**1.0 APPLICATION SUMMARY**

The subject site is Planned Development (PD) 19-0102, as most recently modified by PRS 23-0154. PD 19-0102 covers two non-contiguous development areas with transferred density from one area (Bullfrog Creek Mitigation Area) to the other area (Berry Bay Receiving Area). The PD is approved for 1,047 residential units (subject to the availability of employment and commercial in the Wimauma Community Plan Village area), a non-charter public school, a passive public park and public use facilities. To date, 946 residential units have received development permit approval, with 101 residential units yet to be approved. This request does not include any request to increase the number of previously approved residential units or expand the PD area.

## AGENCY REVIEW COMMENT SHEET

### 2.4 Proposed Site Plan (partial provided below for size and orientation purposes. See Section 8.2 for full site plan)

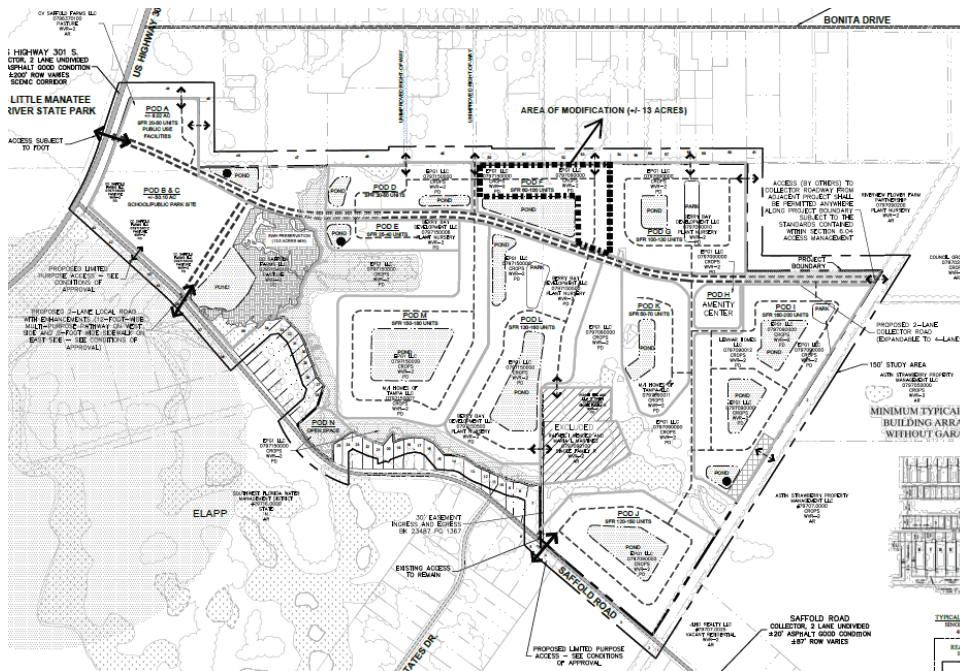
1. On both Sheets 3 and 4, revise the “Area of Modification” notation for Pod F to “Area of Modification for PRS 23-0154.”

8.2 Proposed Site Plan (Full)

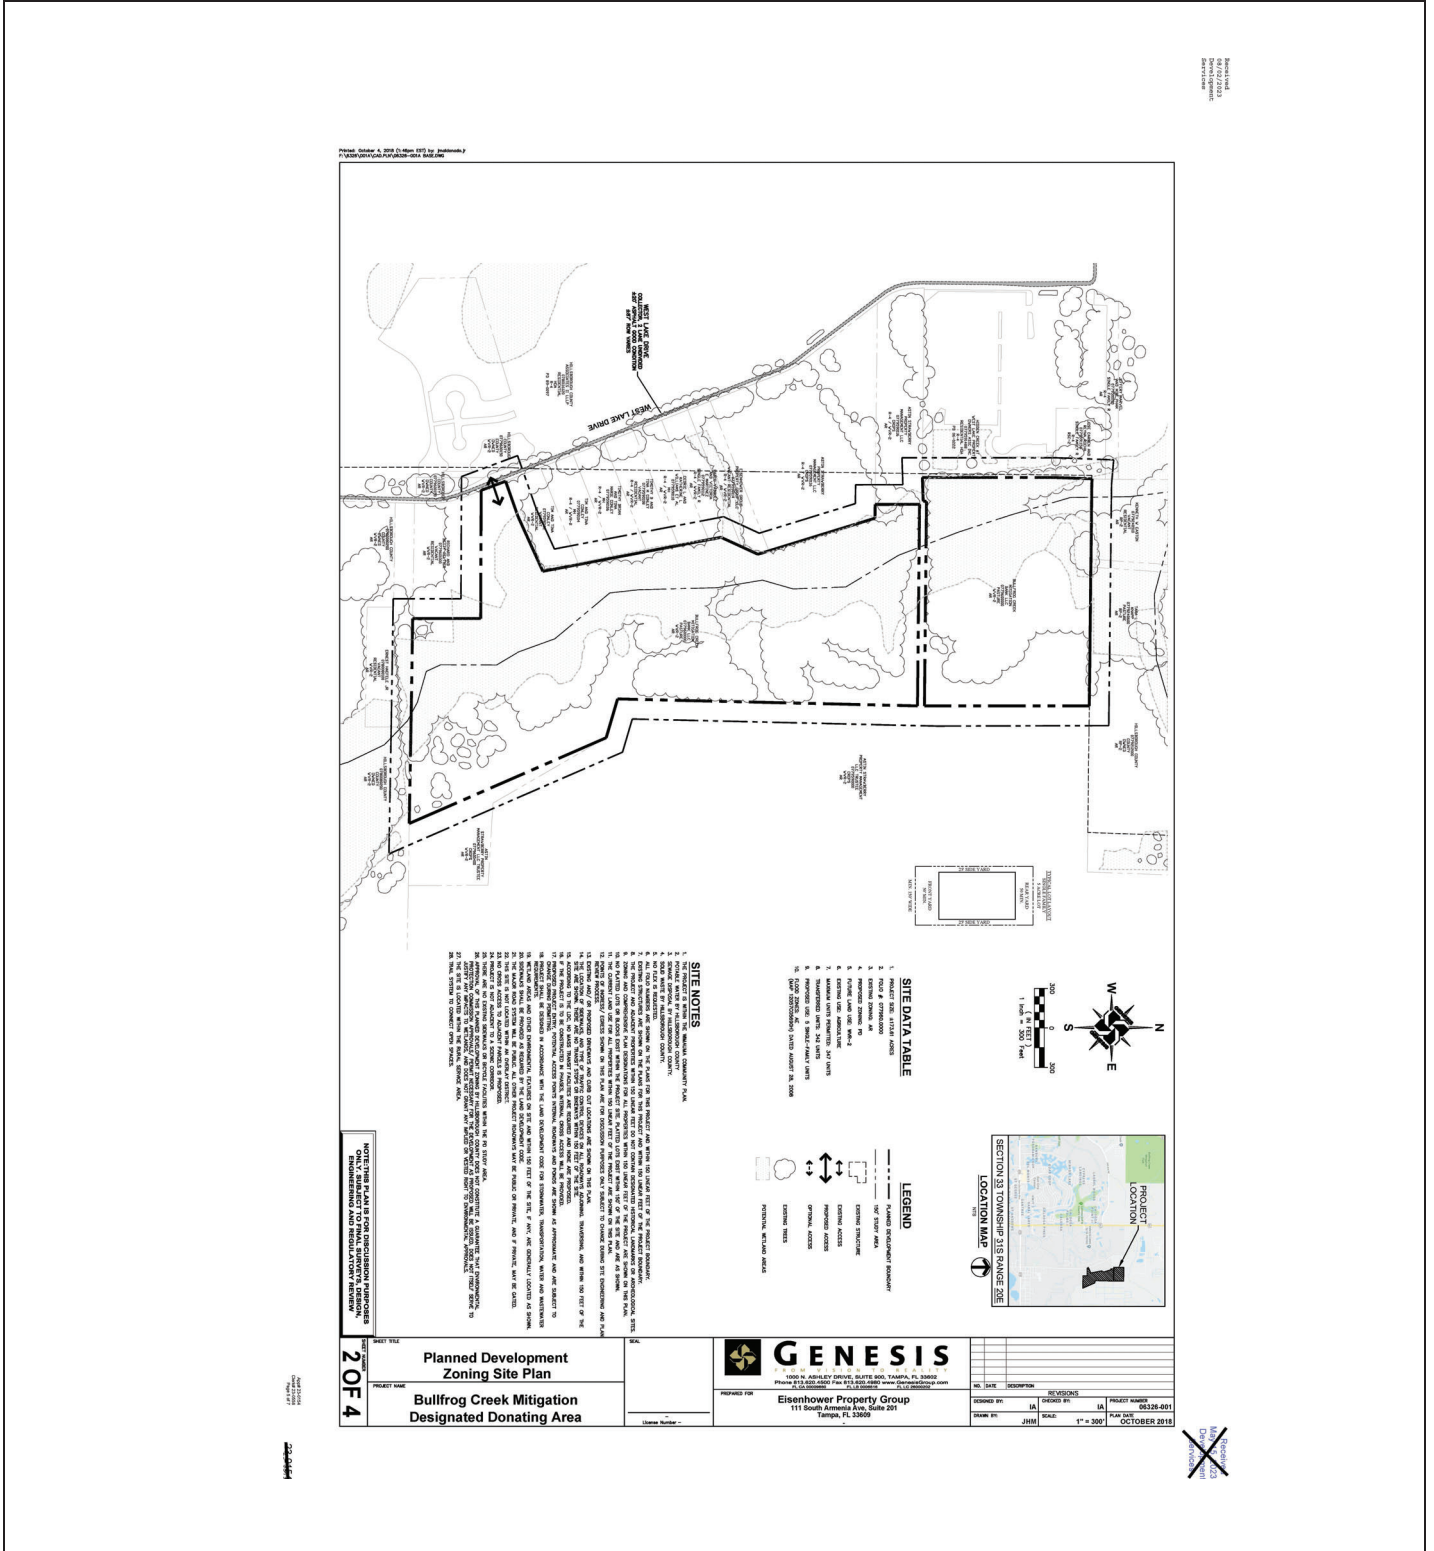
Additionally, staff notes that prior to certification, the PD site plan must be changed to remove references to this plan as modification “19-012” and substitute references for the 23-0879 action, if needed. Similarly, the site plan refers to “an area of modification” within Pod F; however, staff notes that the proposed modification to conditions affects the PD as a whole, and therefore designation of an “area of modification” on the PD site plan, as it relates to this proposed PD modification, is confusing/inaccurate.

These segments are shown in Figure 1.

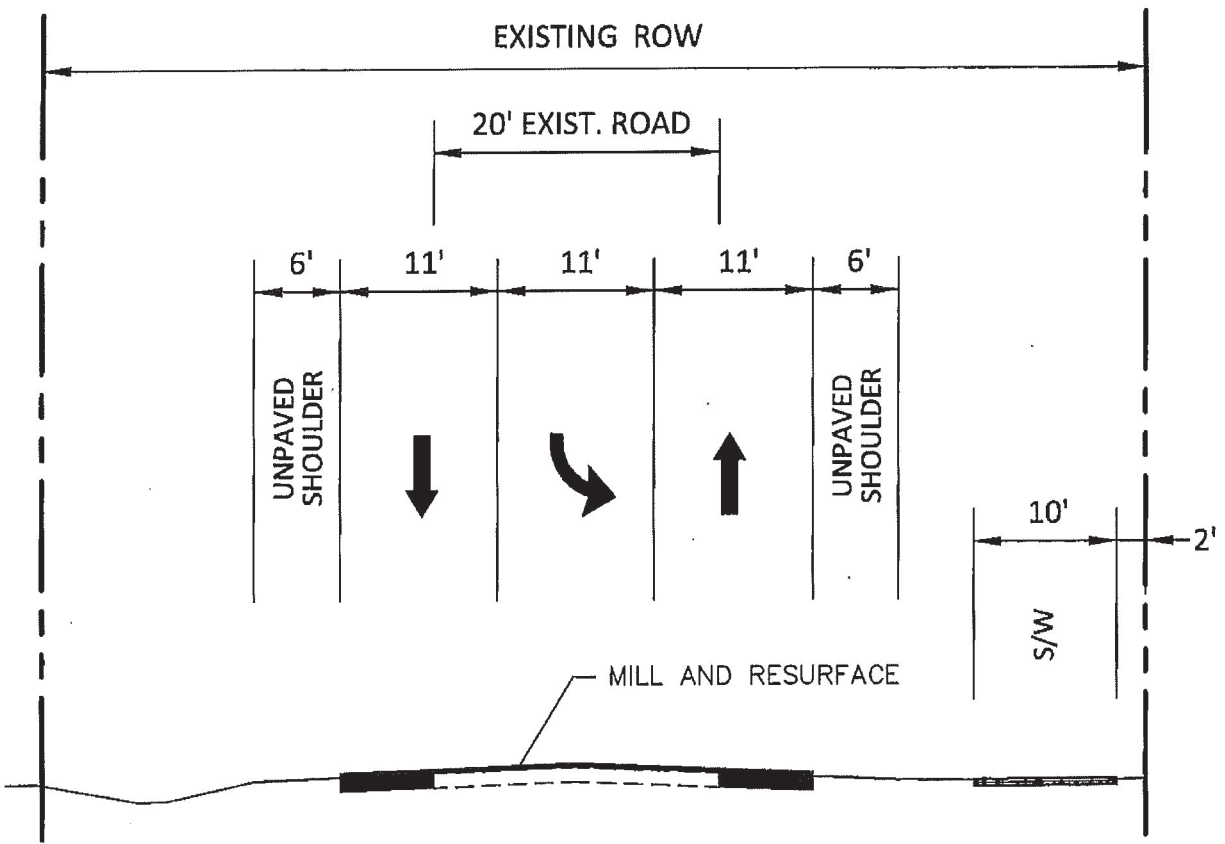
Segment C – This segment includes the section of the roadway from the access improvements to serve the eastern access from the project.

TYPICAL SECTION  
SEGMENT A & C

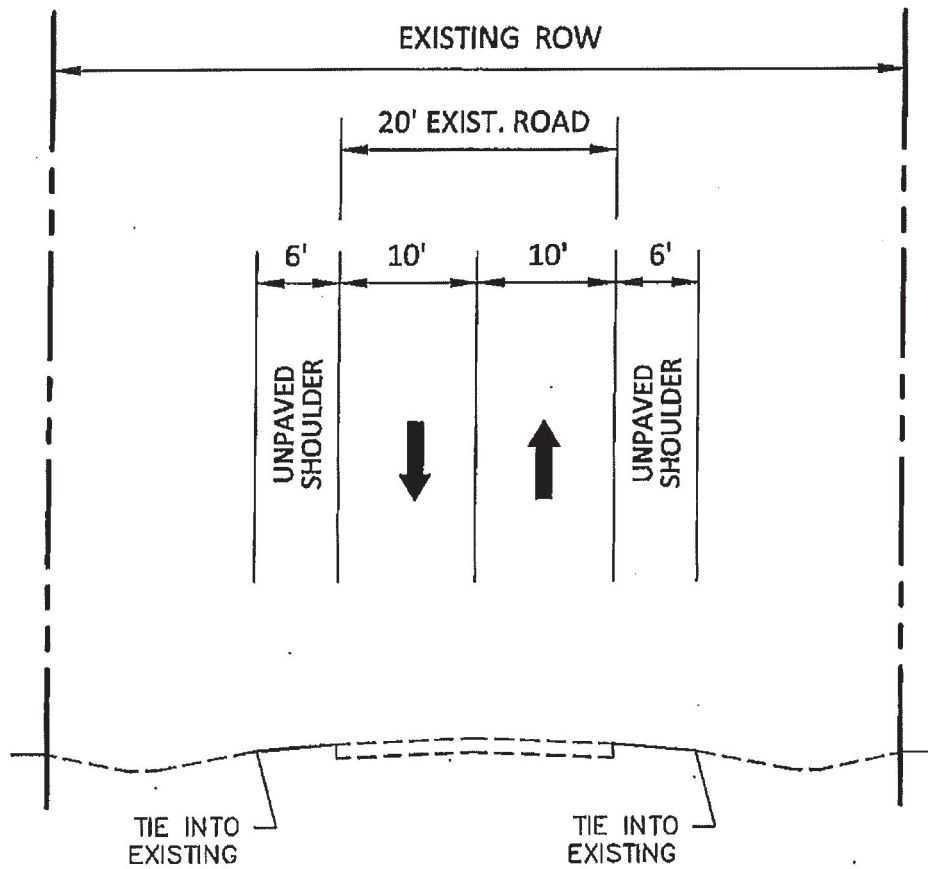
3. Show milling and resurfacing of existing pavement on Seg A & C typical.

The typical section was revised as requested.
